SUBJECT: AFCEE FA8903-08-D-8769-0244; Task Order 0244
MMR SPEIM/LTM/O&M Program
CDRL #A001j
**Final Explanation of Significant Differences for the Installation Restoration
Program Groundwater Plumes at the Massachusetts Military Reservation**

Final
Explanation of Significant Differences
for the Installation Restoration Program
Groundwater Plumes at the
Massachusetts Military Reservation

September 2011

FIGURE 3-1

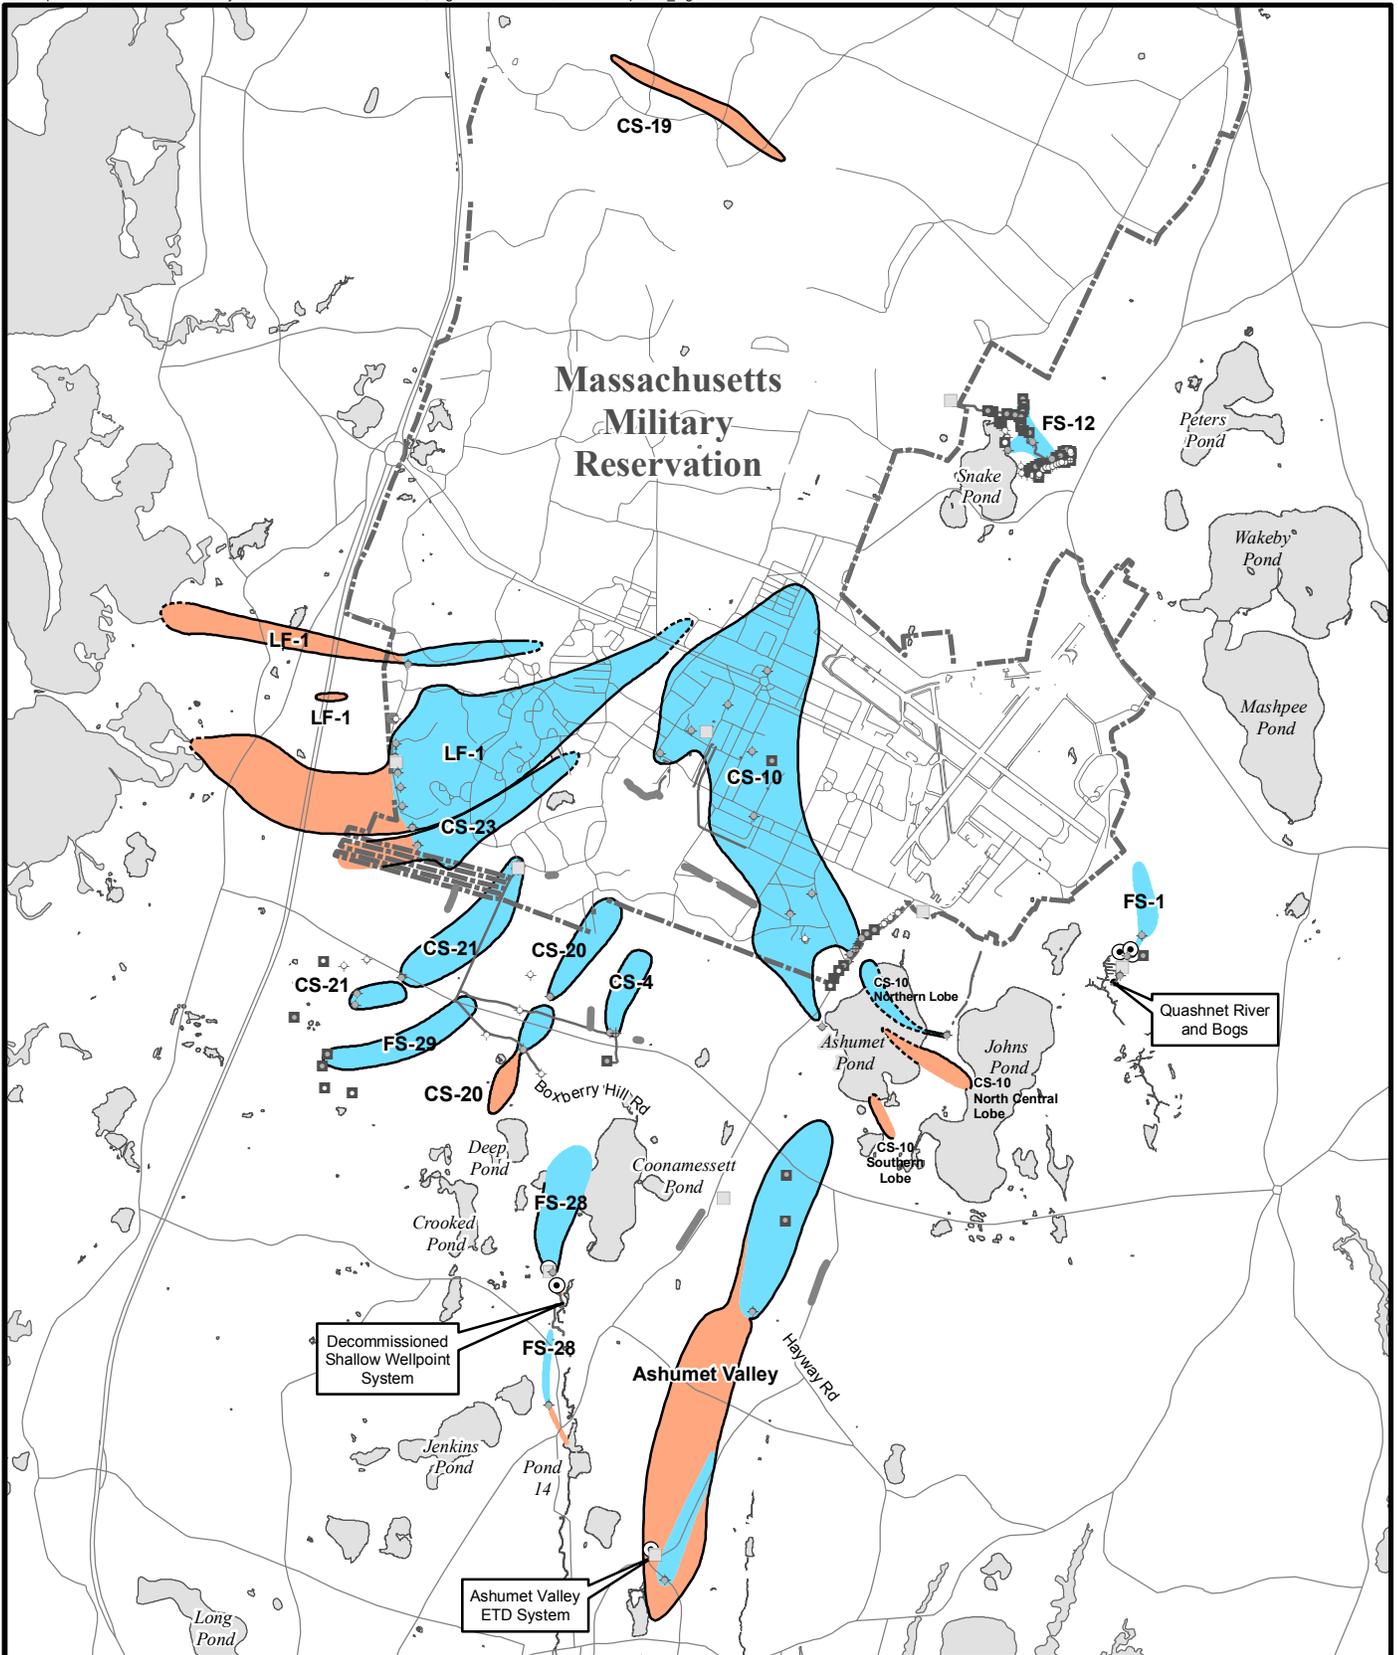
The current (June 2010) extent of the areas subject to the well verification process per this LUC requirement for each of the plumes addressed in this ESD is shown on [Figure 3-1](#). Note that these “LUC areas” for each plume shown on [Figure 3-1](#) are determined based on the current plume boundary. When plume boundaries are updated based on the availability of new monitoring data, the extent of the LUC areas are also re-assessed and re-defined as necessary, with regulatory concurrence.
